TO: Design Review Commission
FROM: Eliana Hassan, Assistant Planner
SUBJECT: SC20-0011 – 698 San Martin Place

Approve design review application SC20-0011 subject to the listed findings and conditions.

This is a design review for a first and second story addition to an existing two-story house. The project includes additions of 546 square feet on the first story and 405 square feet on the second story, with exterior material modifications. The following table summarizes the project's technical details:

Exhibit 1

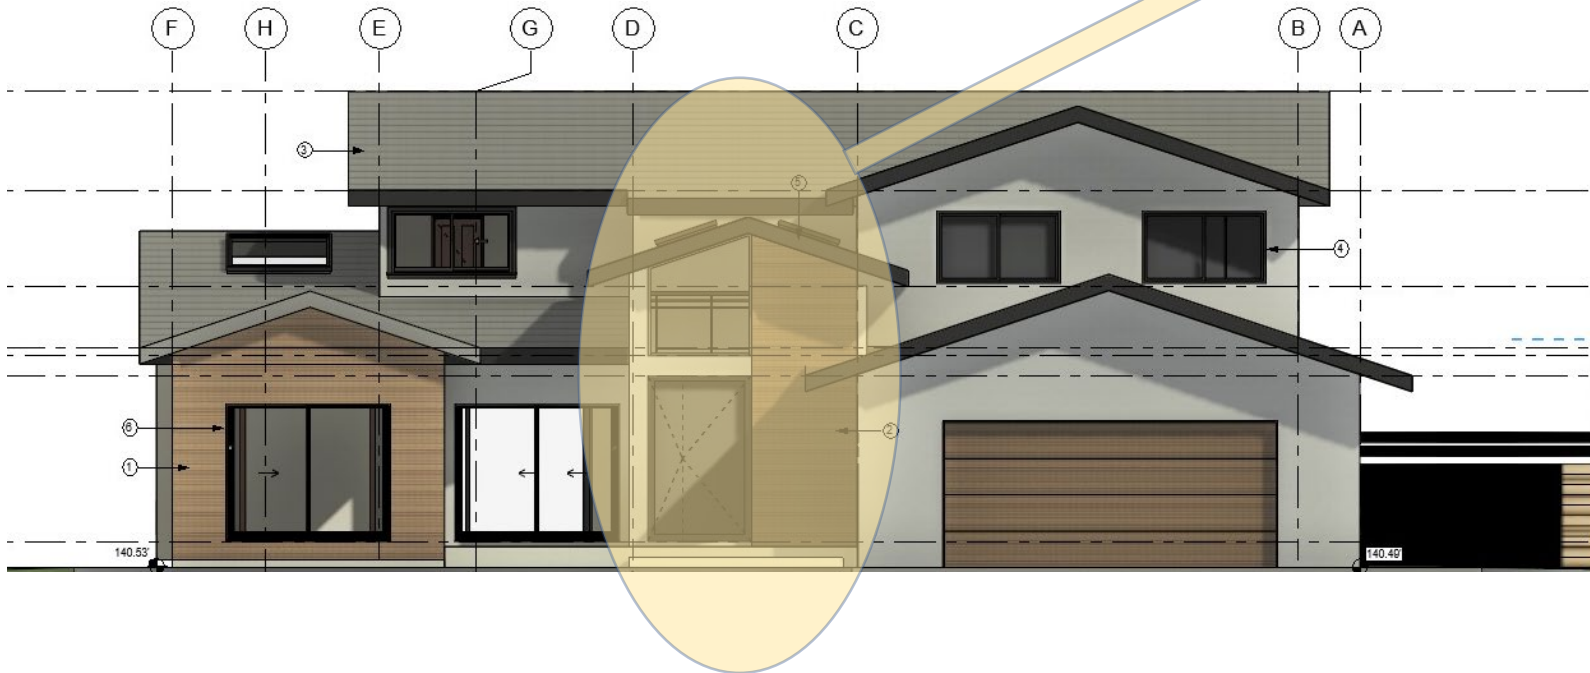
PLANNING STAFF CONCERN:

There are concerns with the massing of the proposed front entryway. The increased height and mass of the front entryway area does not appear to be consistent with the scale of other entryway areas in the neighborhood.

Architect: The Volume of the front entry is created by the stairway connecting with the upstairs. Please consider that this volume balances out the right side of the house with the left. The entry is recessed back from the garage and the entire new addition is designed to minimize the impact on the street. We believe we have blended the addition into the existing home to create a nice balance as per City guidelines.
